Report: EVALUATION
Function: Test, Adjust, & Balance
Date: 10/31/2024
Completed By: National TAB

PROJECT
Chili's - Lady Lake, FL

The purpose of this building evaluation at Chili's in Lady Lake, FL was to provide an overall evaluation of the HVAC systems and balance of the space. There have been concerns about humidity issues within the building as well as balance concerns.

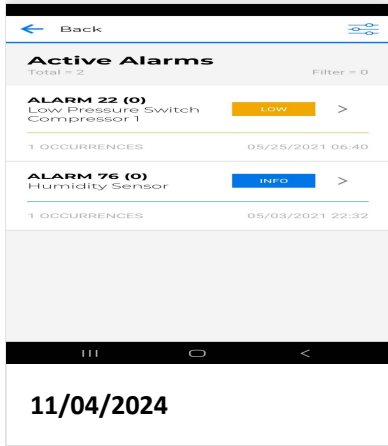
Issue Name : Outside air filter not secure on RTU#1
Description : Outside air filter found laying on roof. Filter was put back into place. Recommended to secure OA filter to the unit.
Created By : National TAB **Assigned To :** National TAB - Ian Fuller
Status : Open
Priority : Medium **Asset Tag :**
Originated Date : 11/04/2024 - Ian Fuller - National TAB

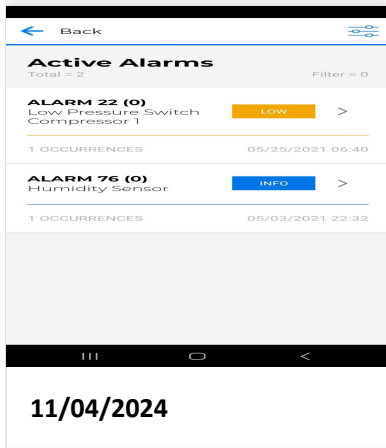
Issue Name : RTU#1 humidity sensor is not wired
Description : RTU#1 has humidtrol on its package details, however, there is no humidity sensor wired to the unit so it cannot dehumidify. Recommended to wire humidity sensor per manufacturers specifications (i.e., two separate shielded twisted pairs required).
Created By : National TAB **Assigned To :** National TAB - Ian Fuller
Status : Open
Priority : **Urgent** **Asset Tag :**
Originated Date : 11/04/2024 - Ian Fuller - National TAB

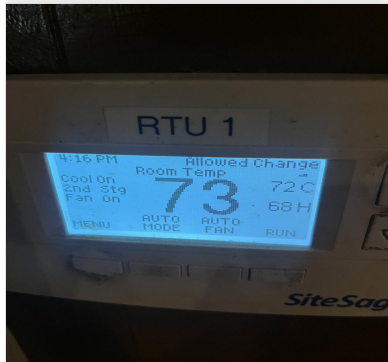
Issue Name : RTU#3 thermostat display is not functional
Description : Thermostat display does not work. Staff is unable to control temperature in space. Recommended to replace thermostat.
Created By : National TAB **Assigned To :** National TAB - Ian Fuller
Status : Open
Priority : High **Asset Tag :**
Originated Date : 11/04/2024 - Ian Fuller - National TAB
